Applicant requests amendment of Figures 2, 3, 4, 5 and 7 as indicated in red on the enclosed amended sheets.

ANNOTATED SHEET

U.S. Serial No. 10/828,905
Filing date: 4/21/2004; GAU: 3751
Docket No. 42526-2800

FIG. 2

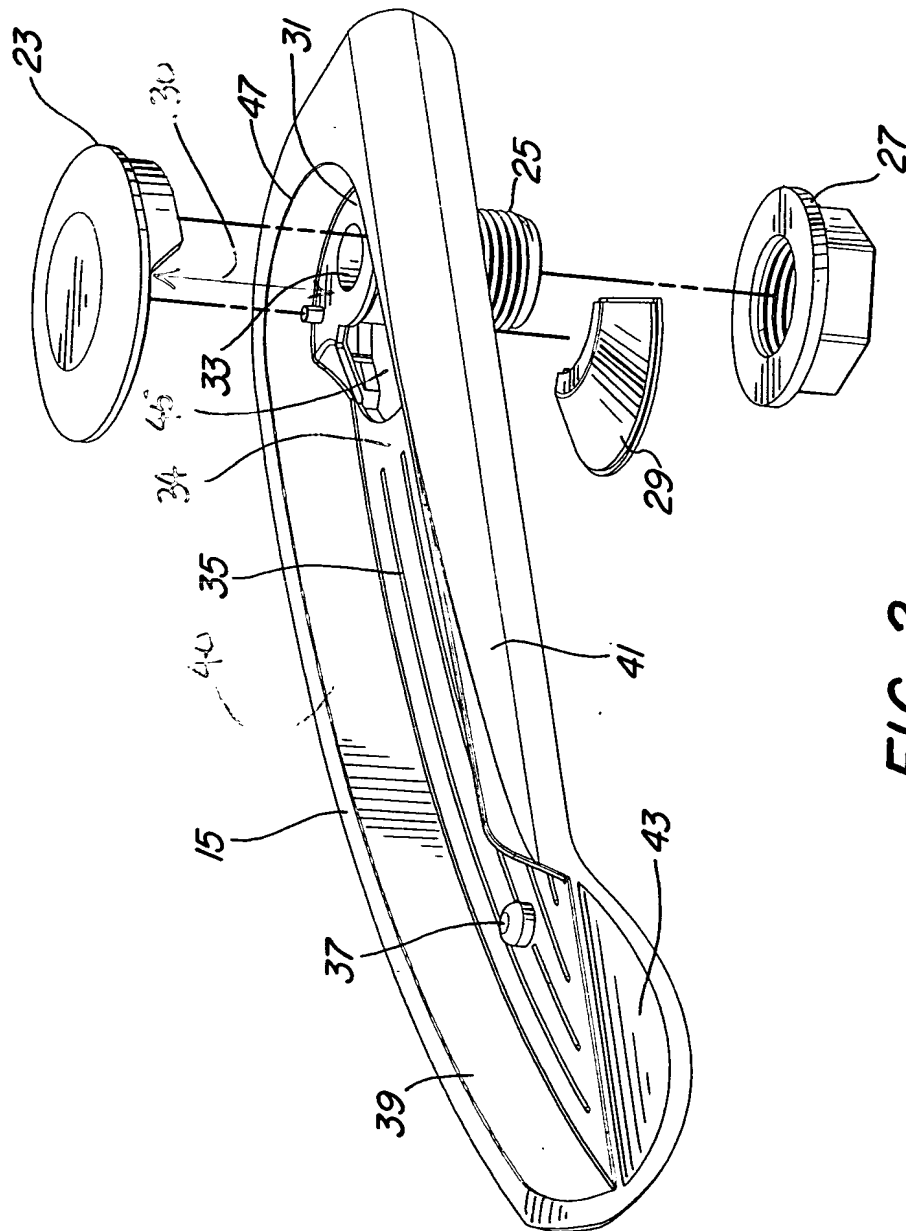
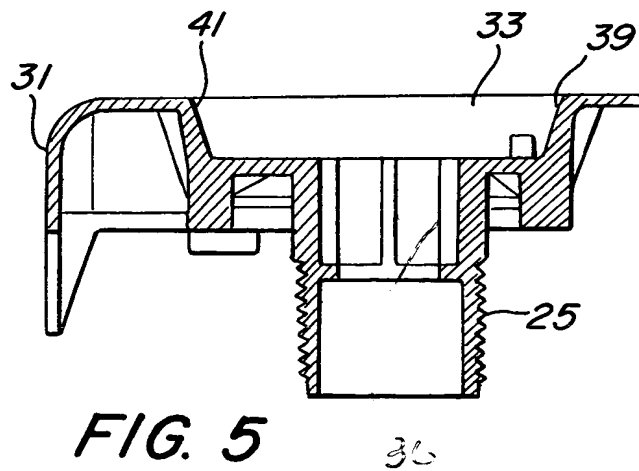
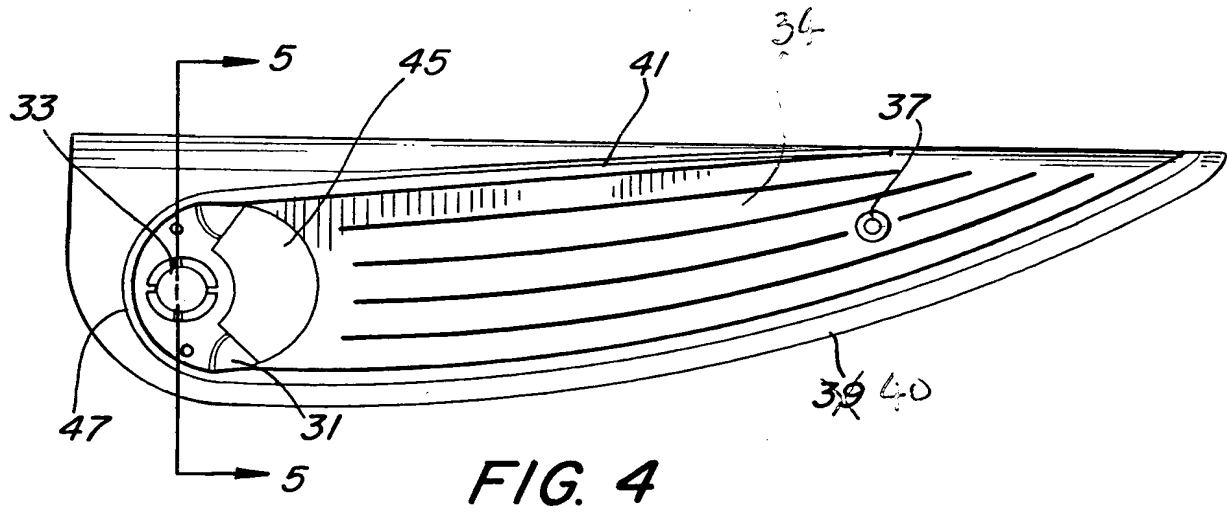
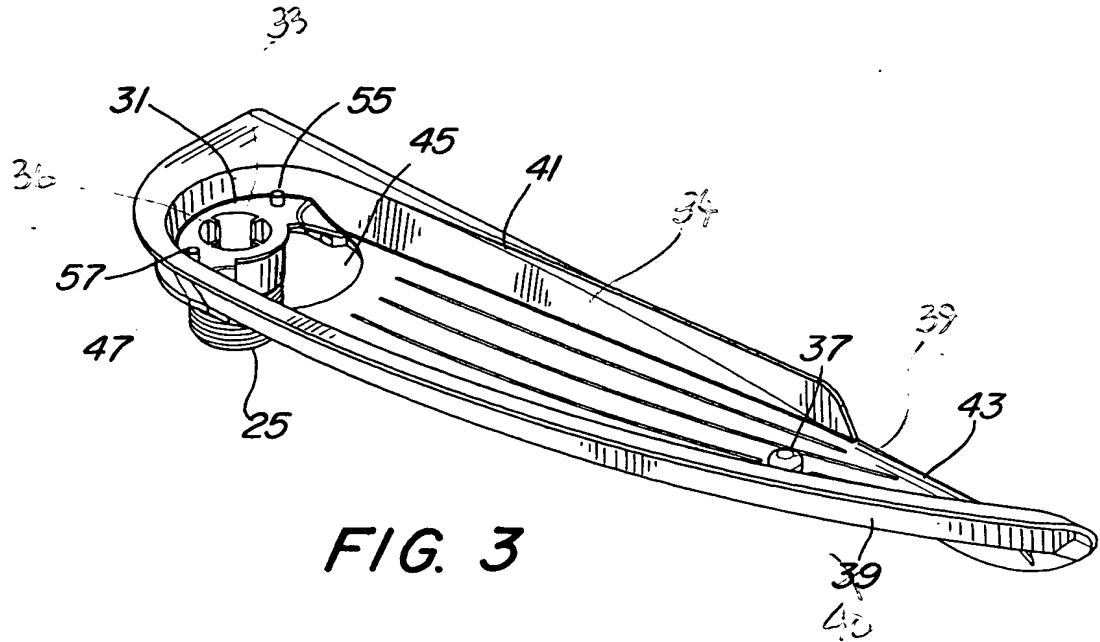
The drawings were objected to because of inconsistent reference numerals and missing reference numerals, as well as other matters.

Reference numerals have been added to Figures 2, 3, 4, 5 and 7. In addition, the reference numeral 39 in Figures 3 and 4 has been changed to 40 to conform with the specification.

Figure 5 was objected to for improper material cross-hatching. Applicant respectfully traverses. The cross-hatching is not for the purpose of showing the material type, i.e. plastic.

Please find enclosed replacement sheets for Figures 2, 3, 4, 5 and 7 with the requested changes incorporated.
